ADDENDUM I

ITB NUMBER: 2025-11DC

ITB TITLE: Video Compression and Processing Technologies Distribution System

ADDENDUM NUMBER: I ADDENDUM DATE: Tuesday, May 19, 2026

AFTER HARMONIC REFRESH

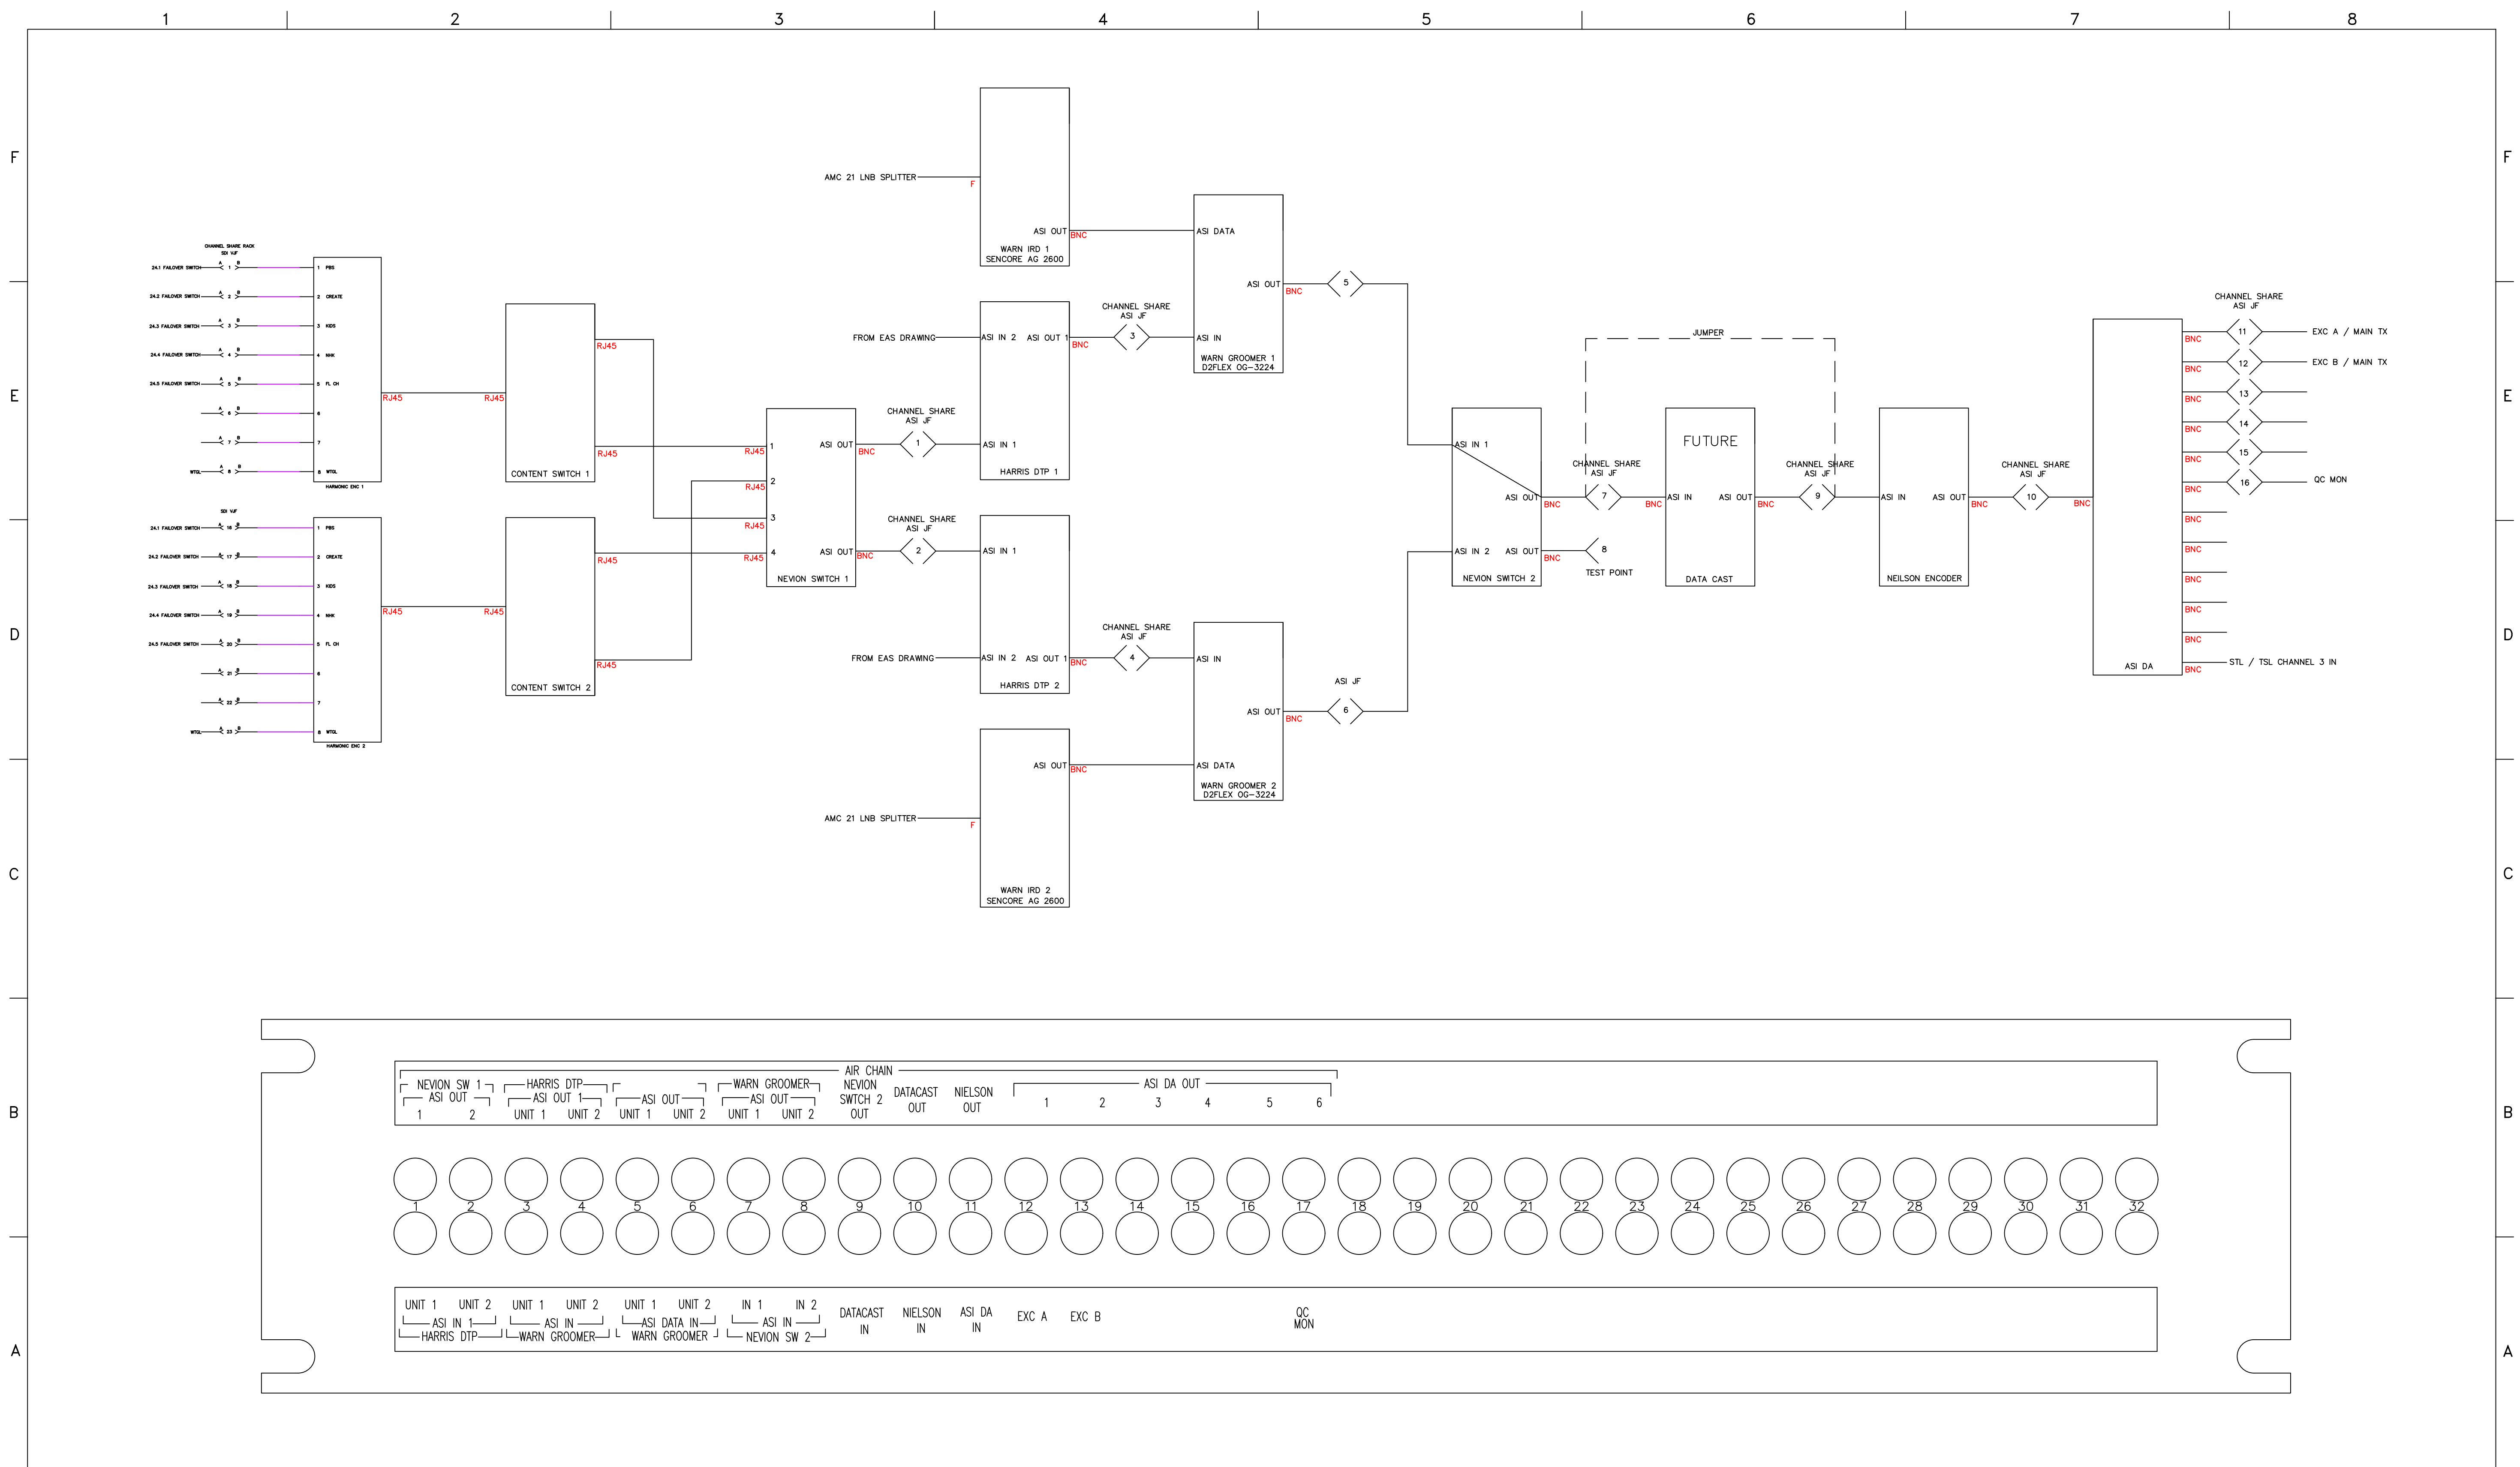
c. Is it under current support?
UCF Answer:
WTGL Yes
11. Supplier Question:
Would you consider other PSIP options?
UCF Answer:
No
12. Supplier Question:
a. Where do you need the Distribution Amplifier for this system?
UCF Answer:
See drawing: TV TECHCORE ASI AIRCHAIN - POST HARMONIC REFRESH. See Attachment A.

b. How does it fit into your workflow?
UCF Answer:
See drawing: TV TECHCORE ASI AIRCHAIN - POST HARMONIC REFRESH. See Attachment A.

13. Supplier Question:
Do you have a DASDEC with EAS-NET License?
UCF Answer:
Yes Primary Online and Offline Spare
14. Supplier Question:
Nevion Virtuoso, are you planning on using these as your Automatic Change Over Switch to Primary Backup XOS?
UCF Answer:
Yes, see drawing: TV TECHCORE ASI AIRCHAIN AFTER HARMONIC REFRESH PDF. See Attachment A.

15. Supplier Question:
What is your need for the second Virtuoso?
UCF Answer:
Yes, see drawing: TV TECHCORE ASI AIRCHAIN AFTER HARMONIC REFRESH PDF. See Attachment A.

SHEET TITLE
ELEVATION
NEW RACKS

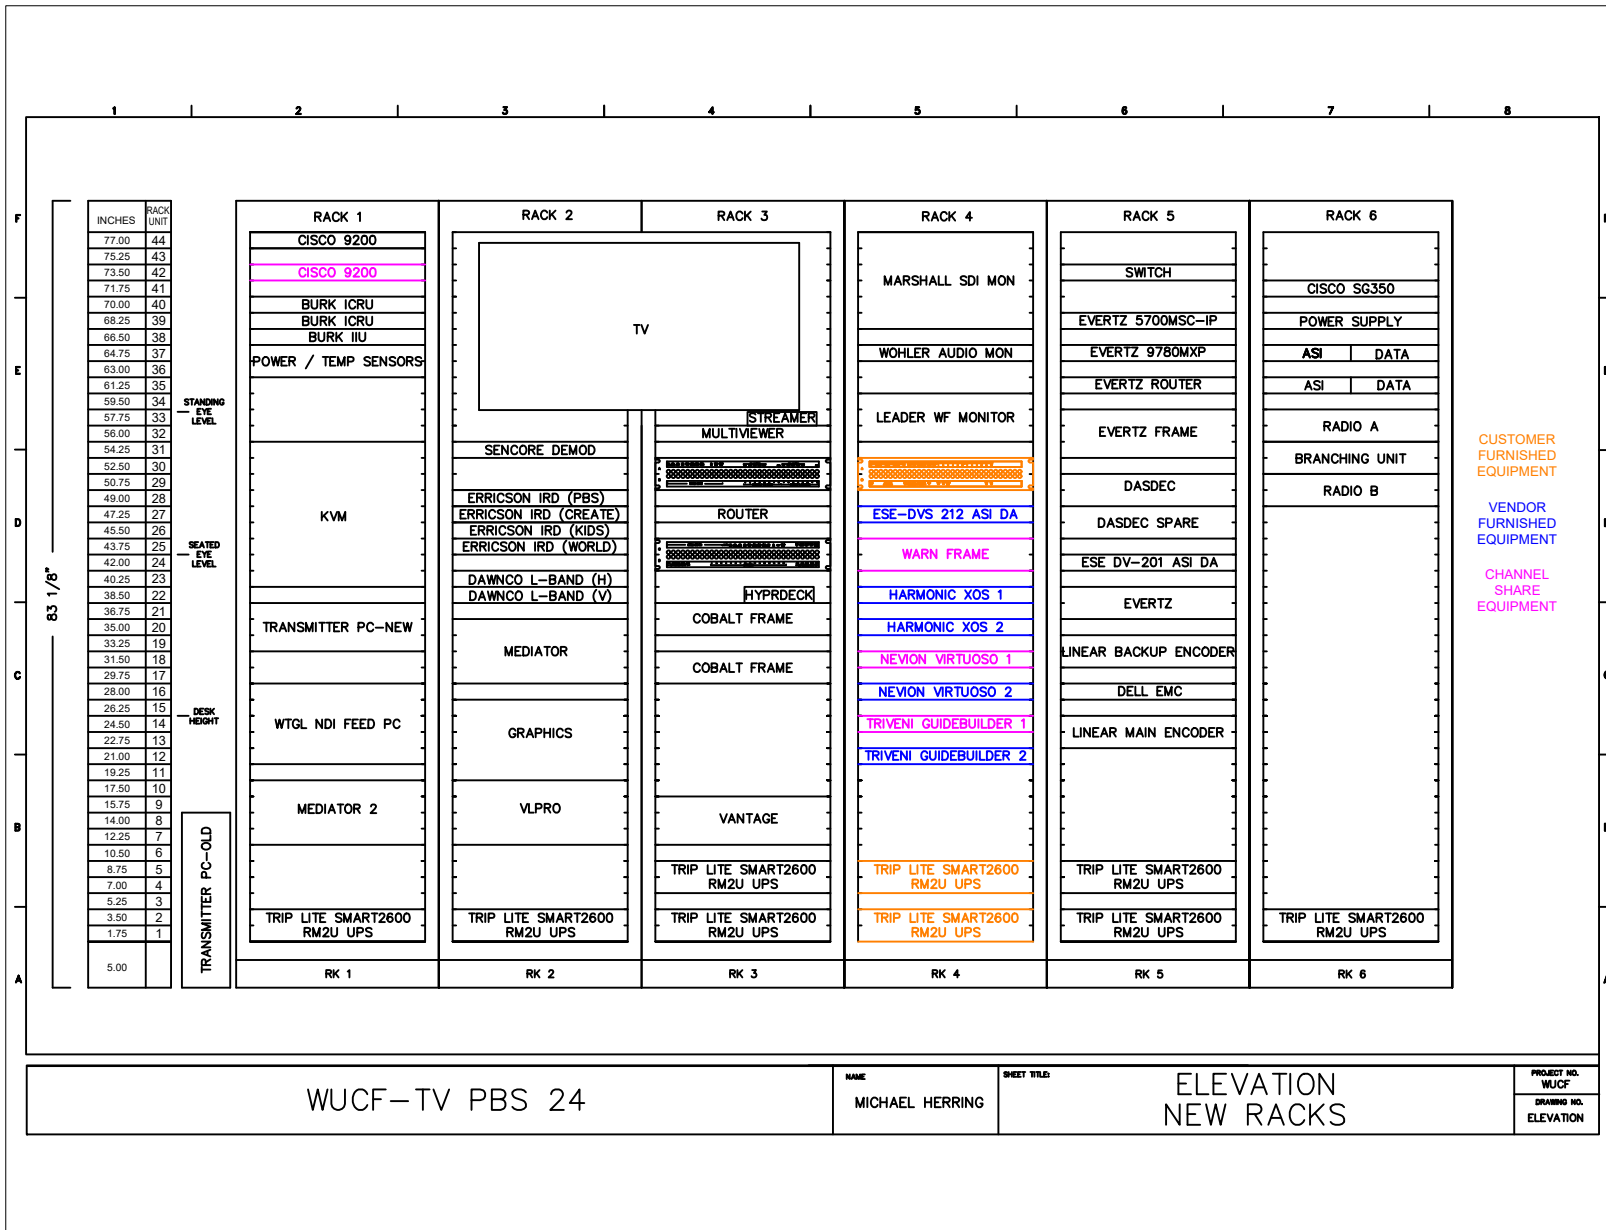
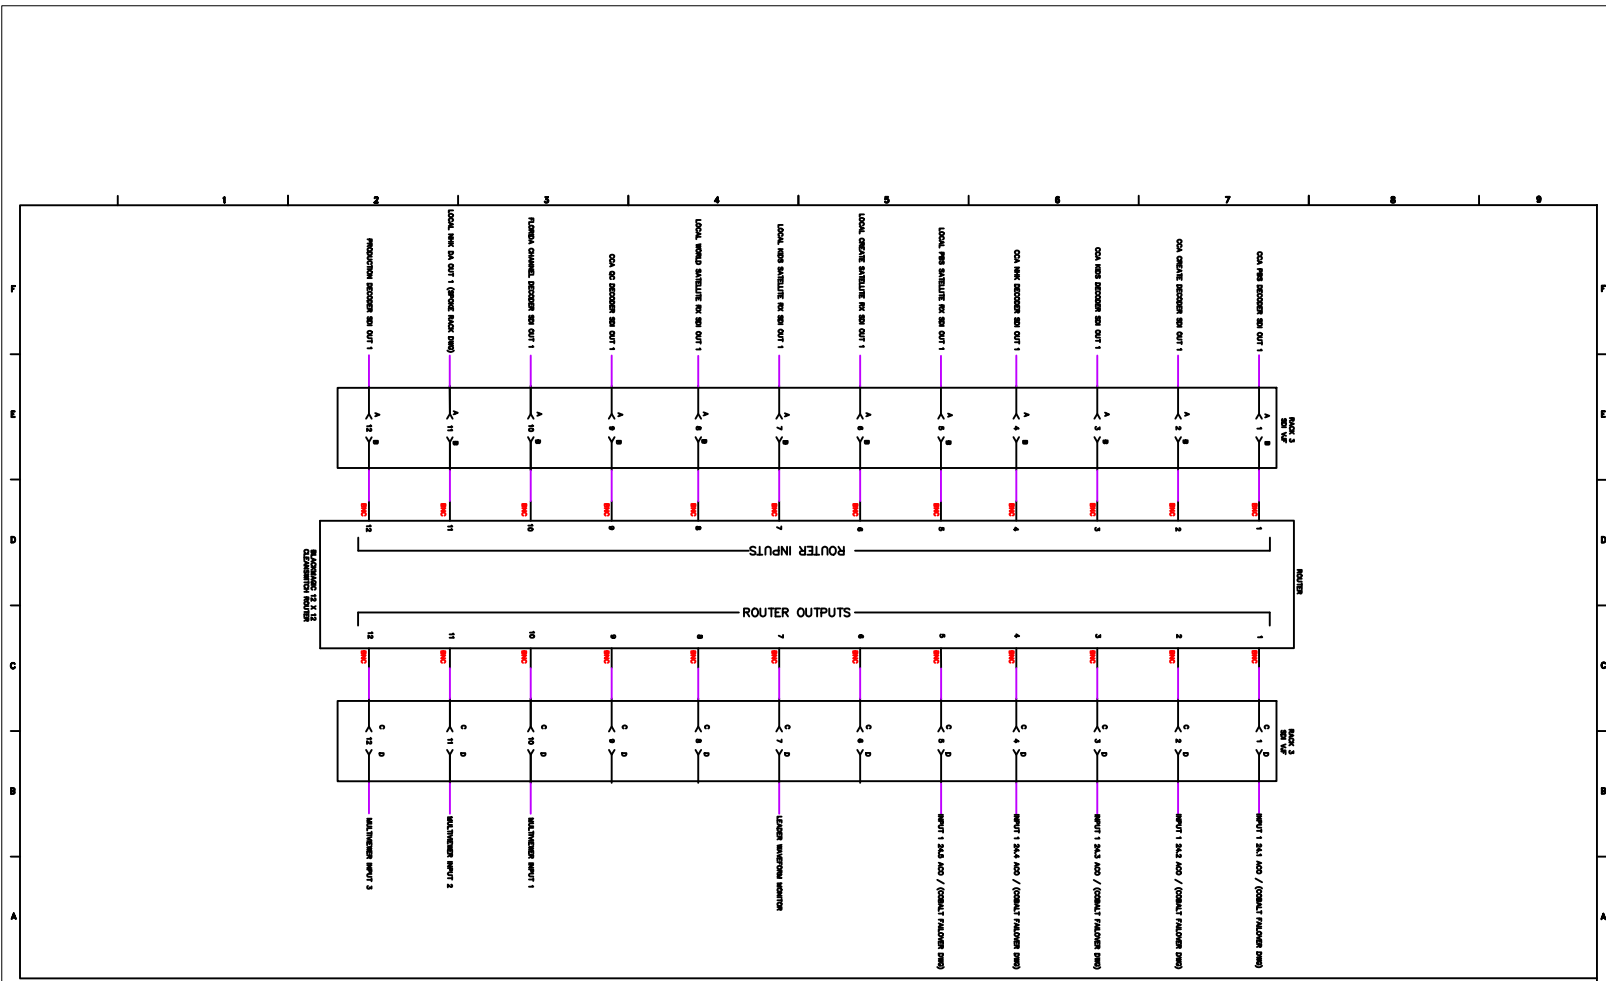
21. Supplier Question:
Install question:
a. Will the new equipment all reside in the same rack?
UCF Answer:
Yes, see drawing: TV TECHCORE RACK ELEVATIONS NEW RACKS - POST HARMONIC. See Attachment A.
